Town of Kittery Planning Board Meeting June 22, 2023

- 4 ITEM 4 27 & 29 Wentworth Street Hotel Site Plan Sketch Plan Review
- 5 Action: Accept or deny application, Approve or deny concept plan.
- 6 **Proposal:** Convert existing bed and breakfast into two independent inns with a total of 12 rental units
- 7 plus 1 innkeeper's suite each.
- 8 **Location**: 27 & 29 Wentworth Street, Map 9 Lots 37 & 38
- **Zoning District**: MU-KF, Kittery Foreside**Owner(s)**: Madbury Real Estate Ventures
- 11 Agent(s): Brandon Holben

APPLICATION & PLAN REVIEW

27 Wentworth Street - B

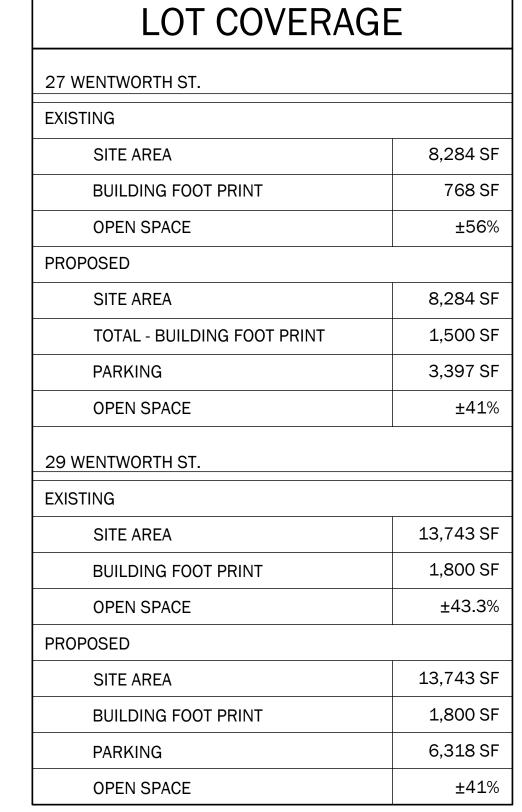
- a. Fire lane markings may be required where driveways slim down at building edges.
- 3. To conform to the 40% open space requirement if the developer utilizes Option B, the shared lot line between 27 and 29 Wentworth would have to be altered to allow the coverage on each site to align with zoning requirements, as notated in the site plan. A full boundary and topographic survey are being completed. Additional research is required to finalize boundary and lot area.
